**AUSTRALIAN INSTITUTE OF LANDSCAPE ARCHITECTS (AILA)
OBJECTION TO
CENTRAL BARANGAROO MOD 9 REVISION**

Address: Barangaroo Central and Headland Park
Portal reference: MPO6_0162-Mod-9
Type of Development: Part 3A Mod
Consent Authority: Sydney

OBJECTION TO CENTRAL BARANGAROO MODIFICATION 9 APPLICATION, (Miller's Point and Observatory Hill) - Aqualand – SSD- Infrastructure NSW - Section 75W Modification Request; Application No MP 006 0162 MOD 9

Figure 2: Thalís et al. 2006, *East Darling Harbour Report : Elevation*, p. 21

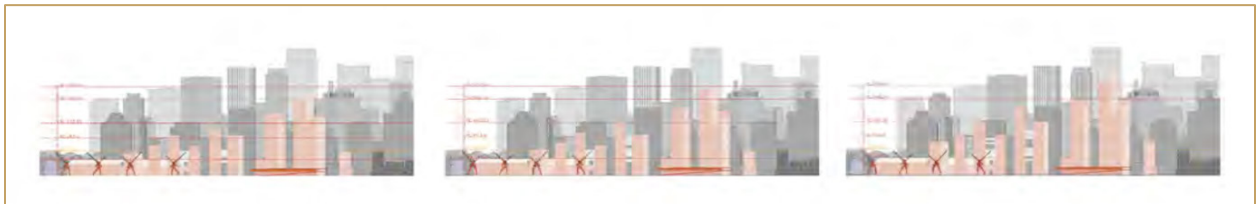
- The proposed mass blocks significant views
 - westward to the harbour waters from the housing
 - westward to the harbour waters from west of Kent Street alignment and
 - panoramic views from Observatory Hill which is largely public open space.
 - to Observatory Hill from opposite foreshores
 - to Observatory Hill from the water
- The original winning design for the 2006 competition (Hill Thalys Architecture + Urban Projects, Paul Berkemeier Architect, Jane Irwin Landscape Architecture; EDH Report 2006) held respect for the public housing forms and the central preschool site which had a strong vista formed to the west. The built form should be low enough to allow for public gardens on

the rooftop over part of Hickson Road and the development stepping down to the harbour edge. This 2006 scheme demonstrates the need to be more respectful for the heritage fabric of the place and views in and out.

Figure 4. Sydney Harbour SHR Nominations AILA NSW :Visual Catchments map, 7 May 2018.

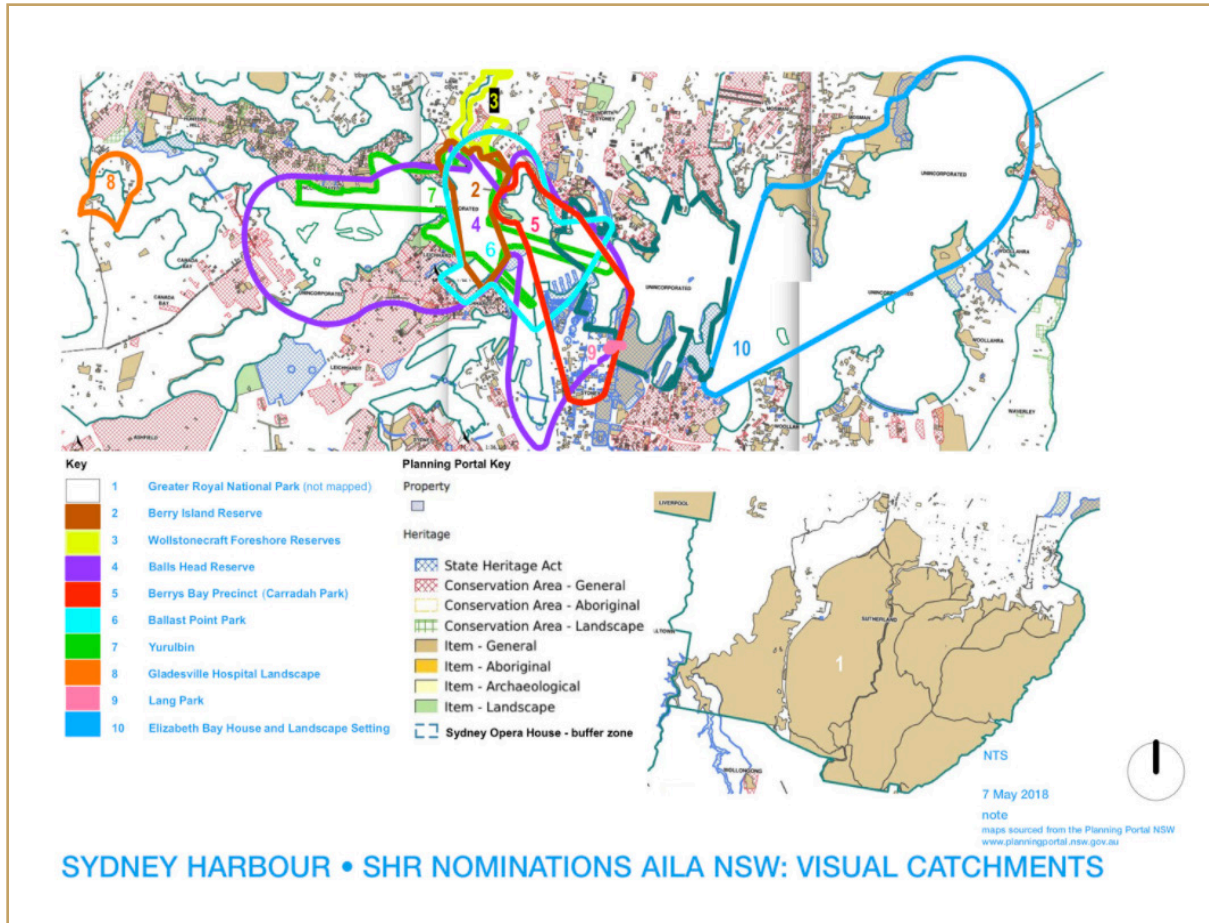
The impact of the proposed development on important visual connections between all of the identified 'Green Necklace' sites; Badangyi, Balls Head Reserve, Berrys Bay Precinct, the Coal loader, Observatory Hill, Balmain and the Bays Precinct and the water itself, must be assessed as part of the proposal. Refer to the [Sydney Harbour SHR Nominations AILA NSW :Visual Catchments map, 7 May 2018.](#)

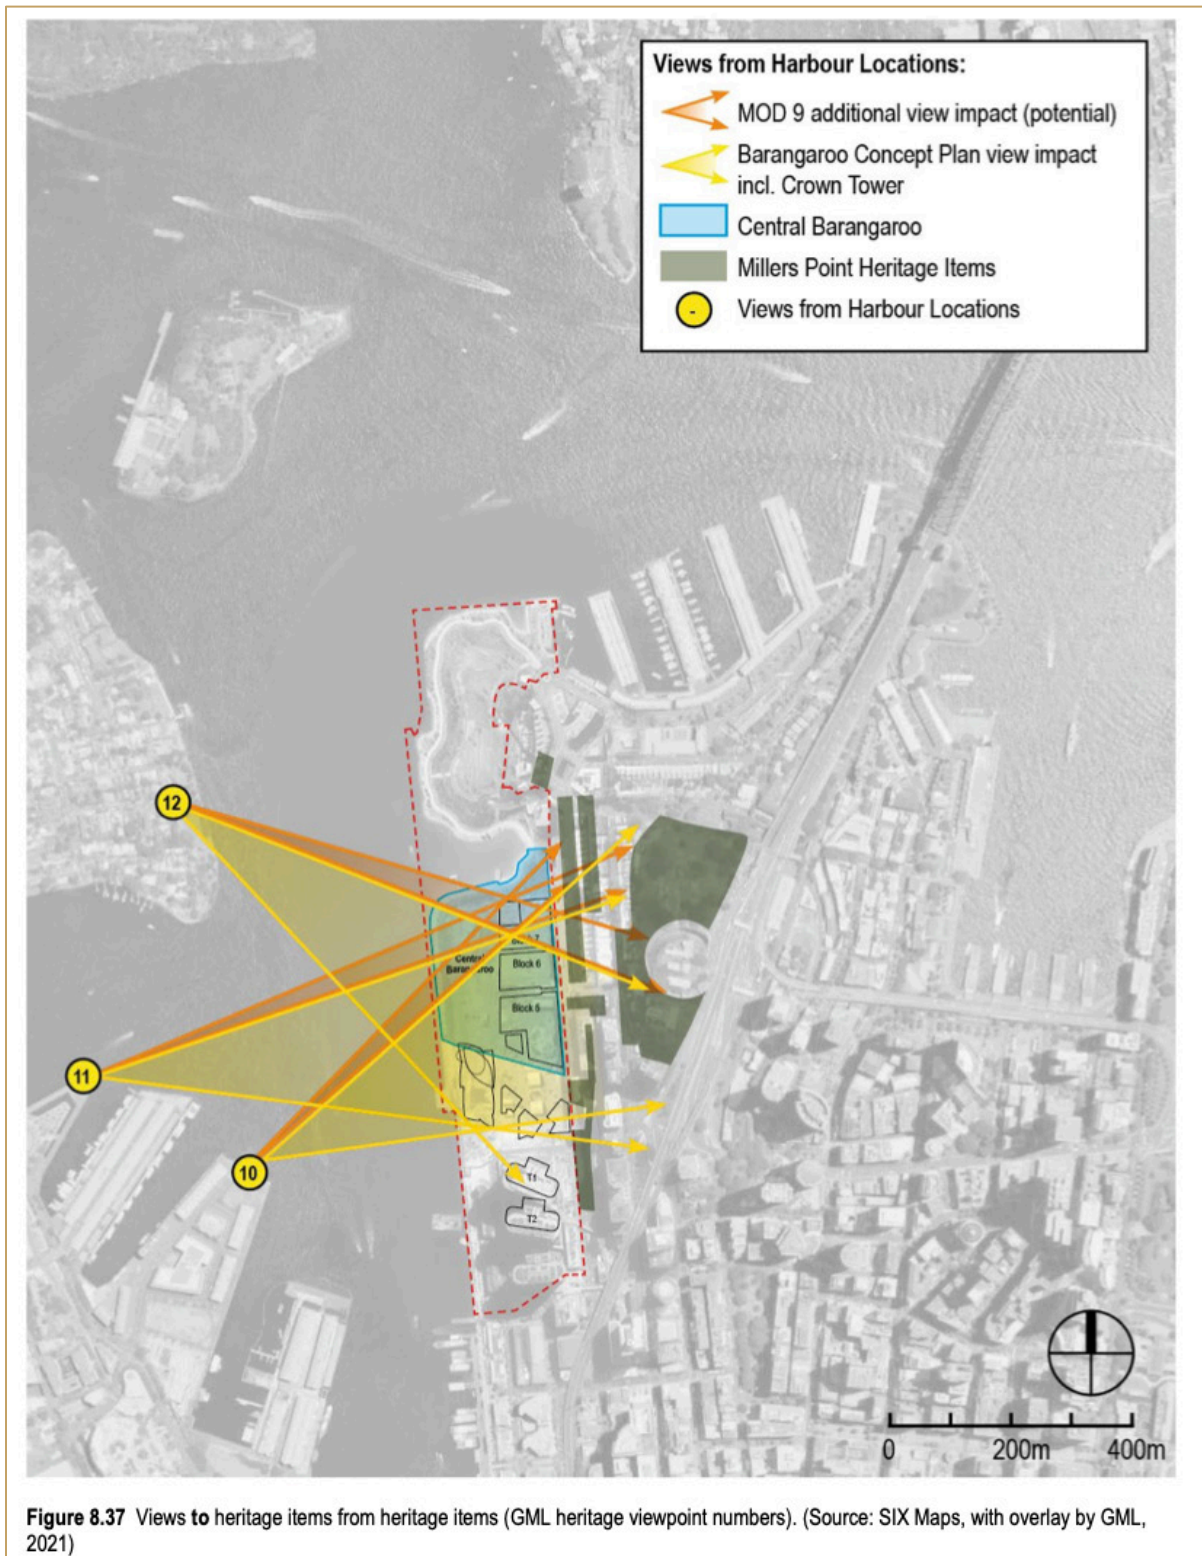
yet the view mapping, Figures 8.37, 8.38 and 8.39, and concluding remarks of the Heritage Assessment and Impact Statement (HAIS) on page 158 demonstrate that appreciation of these qualities will be impossible;

'Views to Observatory Park from Ballarat(sic) Park and Pirrama Park will involve an additional minor loss of views to the tops of trees in Observatory Park and the Observatory itself, as proposed under MOD 9'.
